1.5	لت	- 3"	55	1 -0	_								/	<u> </u>	1 22 37	1 -5 00		'	STZE CODE THENT NO. I	I DEV	<u></u>
																								D OSUV8 B64-1	.3UZI r	\
																								BLEED AIR ECU DUCT RE		
			8						7		6		5					4				(3	2	86413021, 02	_
Ц									•		<u>~</u>							*		1				_	-

SHEET DATE OF CHANGE ECO NO. REQUESTED BY ENGINEERING CHANGE ORDER ΩĒ PREMIER AVIATION, INC. 2621 AVIATION PARKWAY, GRAND PRAIRIE, TX 75052 FSCM - OSUV8 **ENGINEERING** ECO 5471 FAA SUBMITTAL ISTC(s) AFFECTED: SH8443SW **APPROVALS** YES χ NO PREPARED BY DATE 03/19/98 C.R. SHORT REASON FOR CHANGE DOCUMENT AFFECTED CHECKED DATE FACILITATE FAB DESIGN ERROR REVISION 4/6/98 CUSTOMER CHANGE **IDRAFTING ERROR** NUMBER IS WAS DATE QUALIT! DESIGN CHANGE ADDITION DESIGN INFO B64-13021 С С 10/19/94 OTHER TITLE BLEED AIR ECU DUCT ROUTING TYPE CLASSIFICATION INCORPORATED DAGINEERING RECORD PMA MINOR TSO MINOR /110 UNINCORPORATED ISTC IPMA MAJOR TSO MAJOR (NOTE TO INCORPORATOR: USE NEXT AVAILABLE DESCRIPTION: NOTE NUMBER UPON INCORPORATION) PARTS LIST: SHEET 1 NOTES: ADD PERMISSIBLE TO SUBSTITUTE EQUIVALENT AN960 WASHER ADD -31 AND -73 ASSY FOR NASI149 WASHER UNTIL CURRENT STOCK IS DEPLETED. REFERENCE NASI149 SPECIFICATIO

DESCRIPTION: SHEET 1 ZONE 7A

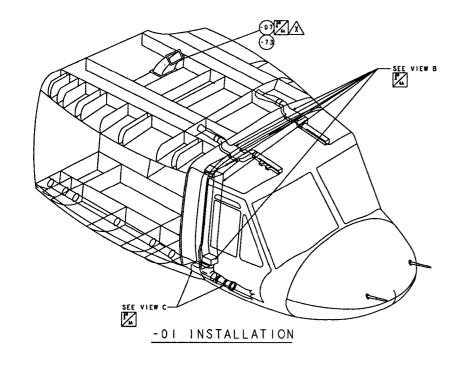
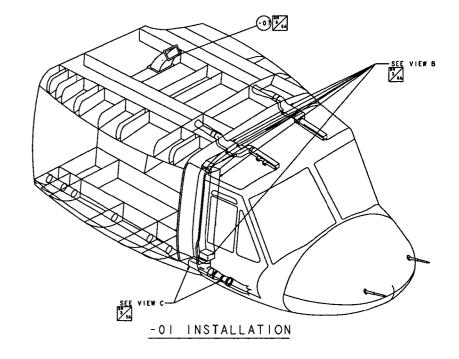
"IS"

"WAS"

SHEET 3 ZONE 3A "IS"

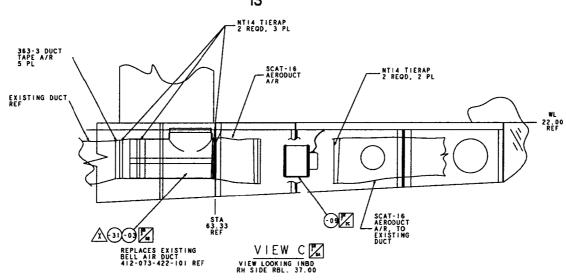
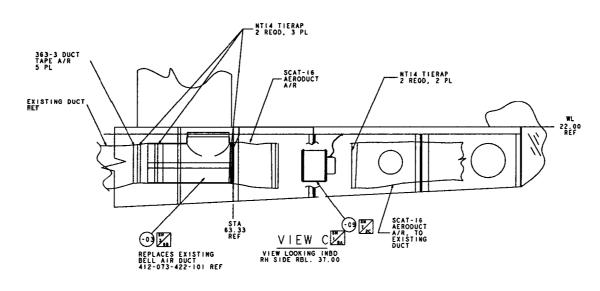
"WAS"

DESCRIPTION: ADD -73

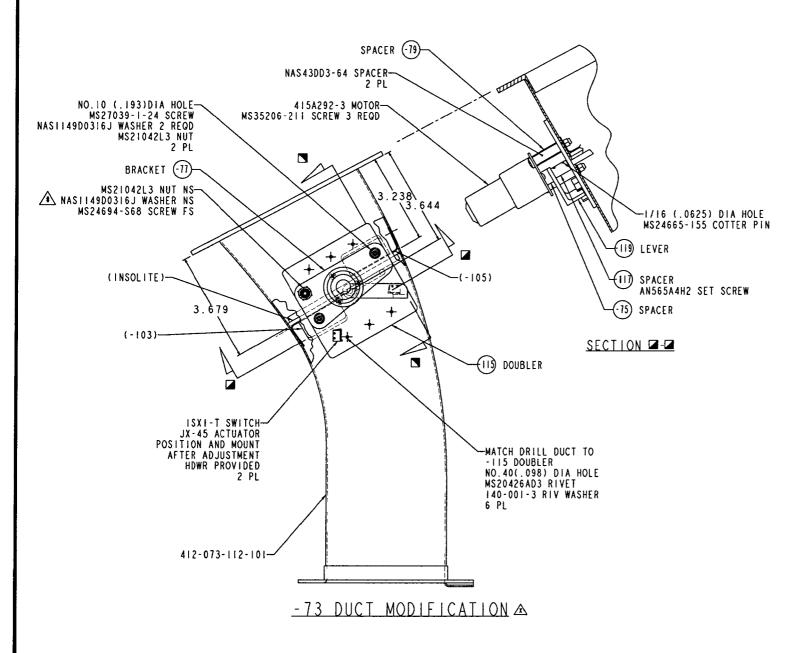
(NOTE TO INCORPORATOR: USE NEXT AVAILABLE SECTION LETTER UPON INCORPORATION)

DESCRIPTION: ADD DETAILS -75, -77, AND -79

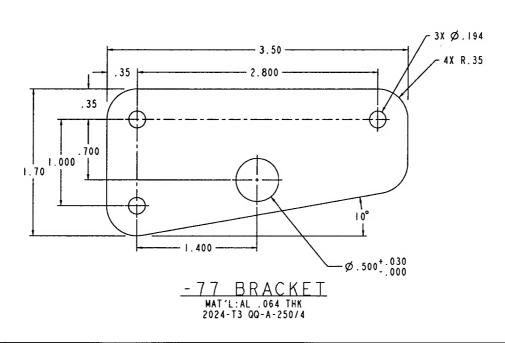
<u>- 75 SPACER</u>
MAT'L: AL .500 DIA BAR 2024-T3 00-A-200/3

<u>-79 SPACER</u>
MAT'L: AL .375 SO BAR 2024-T3 QQ-A-200/3

DESCRIPTION: ADD DETAILS -109 AND -111

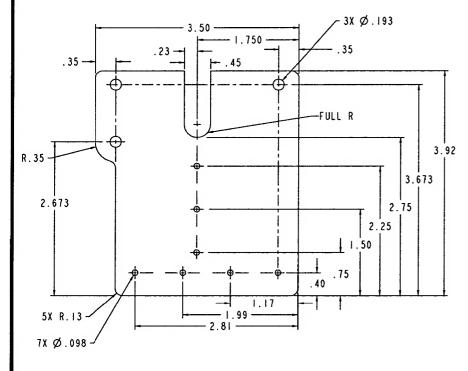
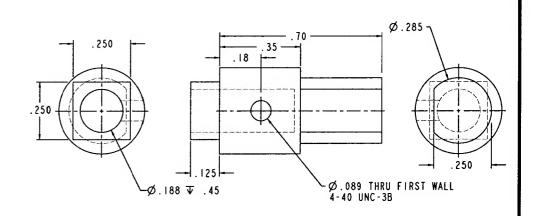
- 109 BRACKET MAT'L: AL .032 THK 2024-T3 00-A-250/4

- | | SPACER MAT'L: .375 DIA BAR 2024-T3 QQ-A-200/3

DESCRIPTION: ADD DETAILS -113 AND -115

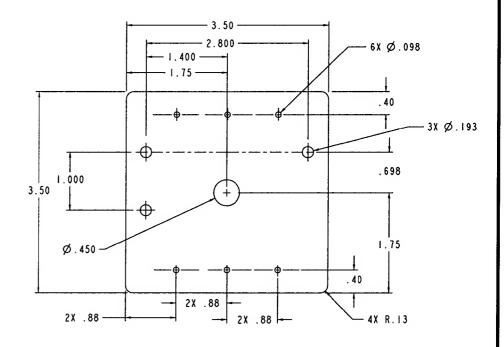
-113 SPACER

MAT'L: AL .125 THK 2024-T3,QQ-A-250/4

DESCRIPTION: ADD DETAILS -117 AND -119

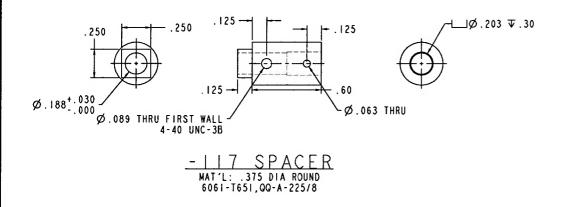
- 1 9 LEVER MAT'L: ANDIO134-1002 2024-T3511,QQ-A-200/3
